Case 2024-8027: 635 Alto Street Development Plan

ATTACHMENT B

DRT Memos

Example for pond measurement post

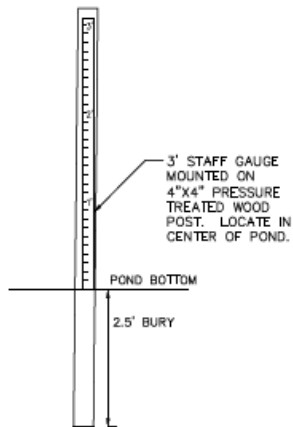
ENGINEER'S STORMWATER INFRASTRUCTURE CERTIFICATION

I, the undersigned professional engineer in the State of New Mexico, do hereby certify that the record information shown hereon is based on actual field measurements and visual inspections performed by myself or under my direct supervision. I further certify that the record condition as of _____ is in substantial compliance with the approved grading and drainage plan prepared by _____, dated _____.
